## SVE BULLETIN

QVM Bulletin: Q-277

### Under Hood Electrical Equipment Mounting

**Models Affected:** 2017 and later Model Year Super Duty Pickups and Chassis Cabs

**Figure 1:** 2017 Super Duty Under Hood Plan View. Low clearance to underside of hood in areas highlighted in orange

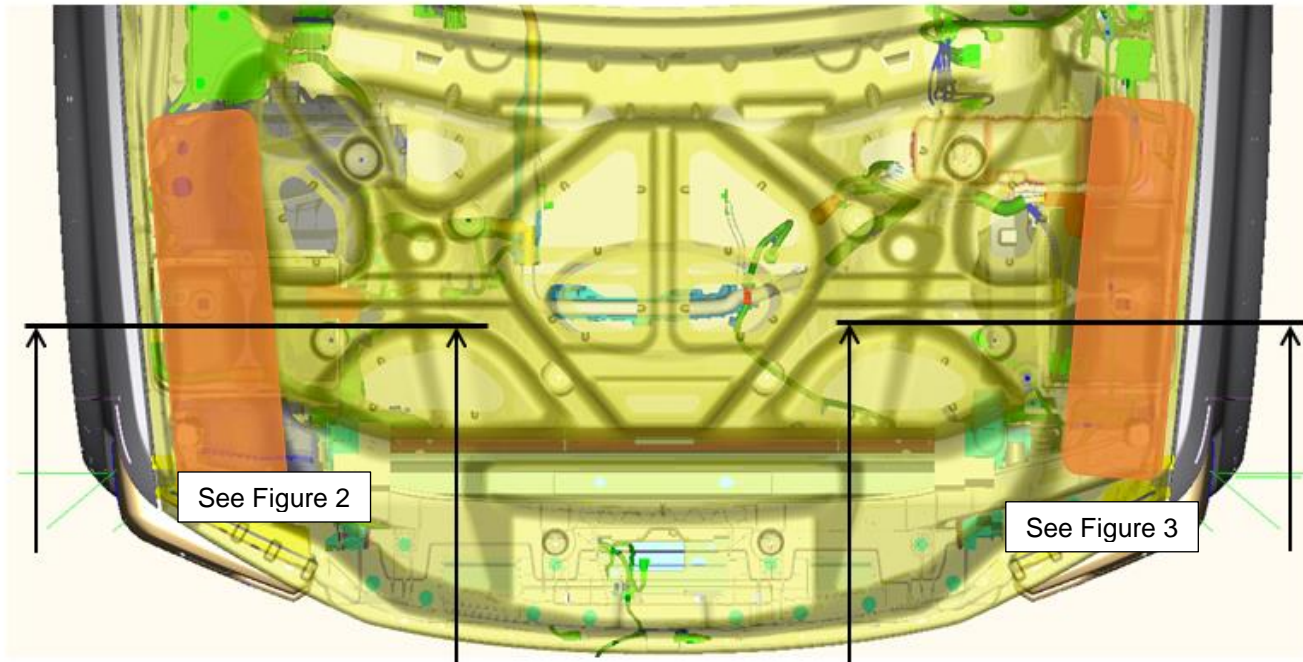
Do not mount or place electrical equipment, including but not limited to connection terminals, cables, relays, fuses, and fusible links on top of or near the primary or secondary battery in a location that has low clearance to the underside of the hood as indicated by orange rectangles in the figures that follow.

The reduced clearance to the underside of the hood for added electrical equipment on top of or near the primary or secondary battery may not be apparent when the hood is open. **If any B+ equipment is mounted in the low clearance zone as indicated by the diagram, a minimum of 15mm must be confirmed between bottom of hood and any equipment (including any B+ shielding and under hood insulation) mounted in the engine compartment when hood is fully closed.** Several methods exist to confirm equipment and shielding meets minimum clearance to bottom of hood (e.g. clay test, bore-scope).

**Note:** only 16 mm clearance from top of negative terminal assembly to underside of hood

**The upfitter must ensure that any electrical equipment or shielding mounted under hood does not come into contact with the hood or hood components.**
